Access Compliance Report

Public Rights-of-Way

(Curb Ramps)

Intersection ID: N/A	Main Street: S_MCDOWELL_ST	Cross Street: E_STONEWALL_ST	Location: NE
ADA ID: A9133DF8FAAE	Ramp Type: Perp	Initial Pass/Fail: Fail	Overall Compliance: No
		Severity Score: 8.75	
Codes/Mitigation Info/Possible Solution		Field Measurements/Component Compliance

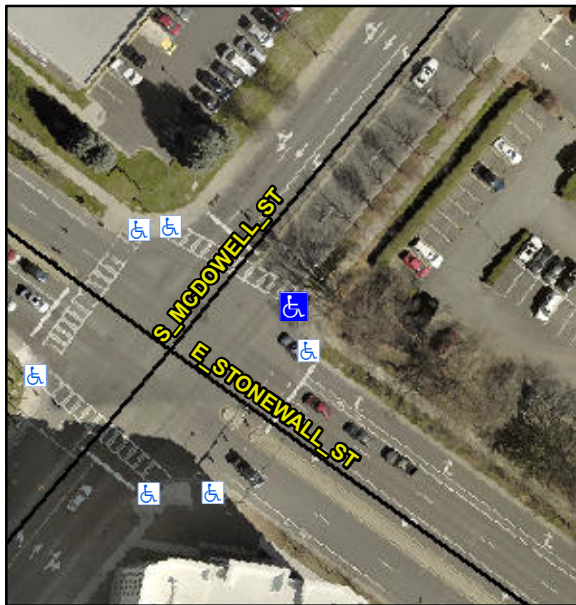
Not Found, R304.5.1

Compliance	Description	Data	Compliance	Description	Data
N/A	Ramp Length (in)	83.0	Yes	Ramp Slope (%)	7.2
No	Ramp Width (in)	46.0	Yes	Ramp XSlope (%)	1.9
N/A	Flare Type LT	N/A	N/A	Flare Type RT	N/A
N/A	Flare Slope LT (%)	N/A	N/A	Flare Slope RT (%)	N/A
N/A	Flare Traversable LT?	N/A	N/A	Flare Traversable RT?	N/A
N/A	Landing Length (in)	N/A	N/A	DWS Provided?	N/A
N/A	Landing Width (in)	N/A	N/A	DWS Contrast?	N/A
N/A	Landing Slope (%)	N/A	N/A	DWS Length (in)	N/A
N/A	Landing X Slope (%)	N/A	N/A	DWS Full Width?	N/A
N/A	Landing Curb? (Y/N)	N/A	N/A	DWS Offset (in)	N/A
N/A	Shared Landing?	N/A			
N/A	Gutter Ponding?	N/A	N/A	Gutter Slope (%)	N/A
N/A	Gutter Lip Ht (in)	N/A	N/A	Gutter X Slope (%)	N/A
N/A	Painted X Walk1?	Yes	N/A	Painted X Walk2?	N/A
	X Walk 1 Direction	To NW		X Walk 2 Direction	N/A
N/A	X Walk 1 Width (in)	110.0	N/A	X Walk 2 Width (in)	N/A
	X Walk 1 Slope (%)	2.5		X Walk 2 Slope (%)	N/A
	X Walk 1 X Slope (%)	2.8		X Walk 2 X Slope (%)	N/A

Remove & Replace Entire Ramp.
